SECTION 96 (1A) APPLICATION - DA16/0357 - EXTENSION OF AWNING AND OTHER MINOR AMENDMENTS

Urbis has prepared this Statement of Environmental Effects on behalf of St Hillier's to accompany a Section 96(1A) application to modify DA16/0357 as it relates to 15 Engineers Place, Penrith (Lot 3008 in DP1184498).

Figure 2 – Level 1 floor plan showing the location of the proposed extension to the awning (see red bubble).

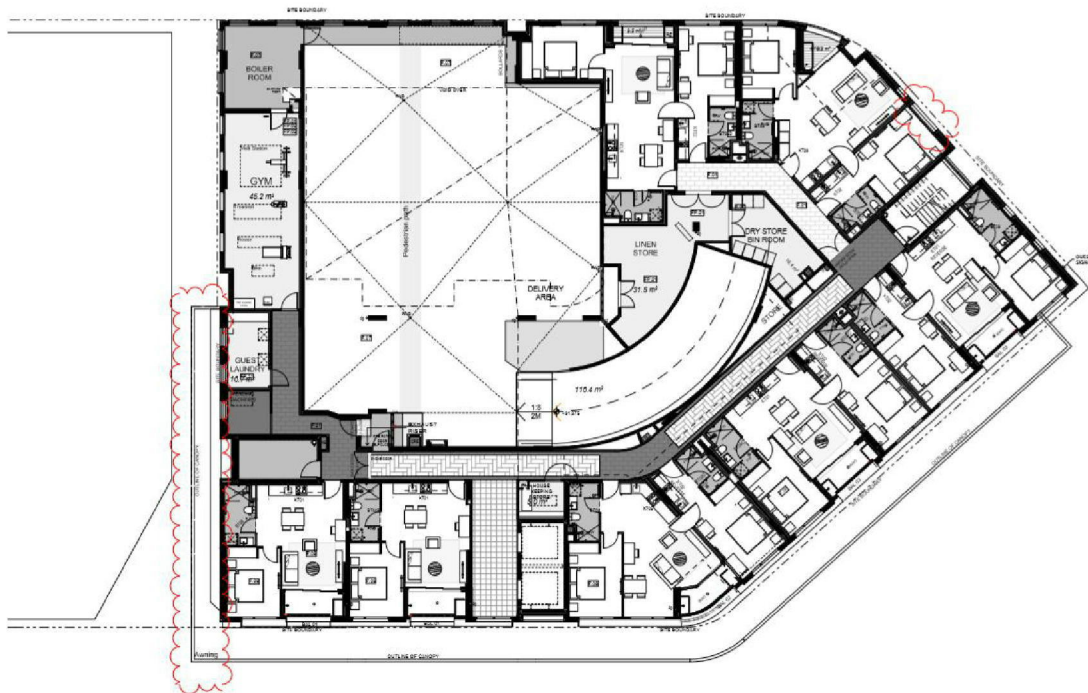
This modification includes the extension of an approved awning to wrap around the front of the building and extend along the pedestrian link located to the north of the building. The extension to the awning will be constructed using the same materials as the originally approved awning. The roof will be made from metal sheeting and the extended awning will sit flush with the building.
